Access Compliance Report

Public Rights-of-Way

(Curb Ramps)

| Intersection ID: 49133 | Main Street: EWERT_CUT_LN | Cross Street: AMBER_LEIGH_WAY_DR | Location: NW |

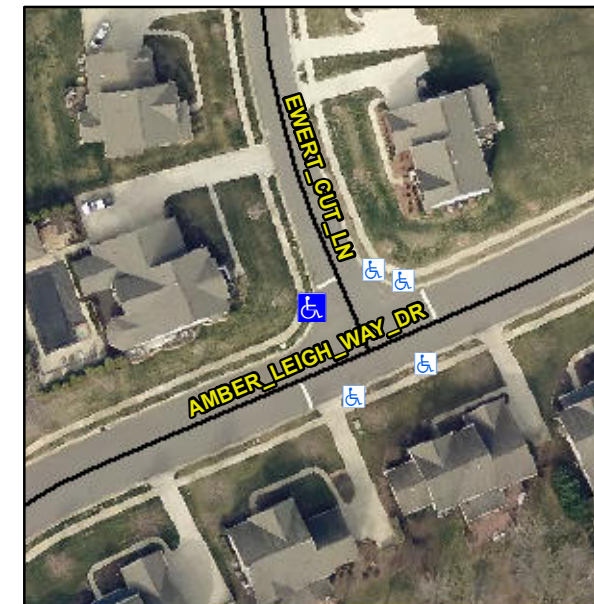
Not Found, R304.5.1, R304.5.3

| Compliance | Description | Data | Compliance | Description | Data |
|------------|-----------------------|------|------------|-----------------------------|------|
| No | Ramp Width (in) | 47.5 | No | Ramp XSlope (%) | 3.0 |

Remove & Replace Curb Ramp With Two New Directional Ramps or Equivalent.
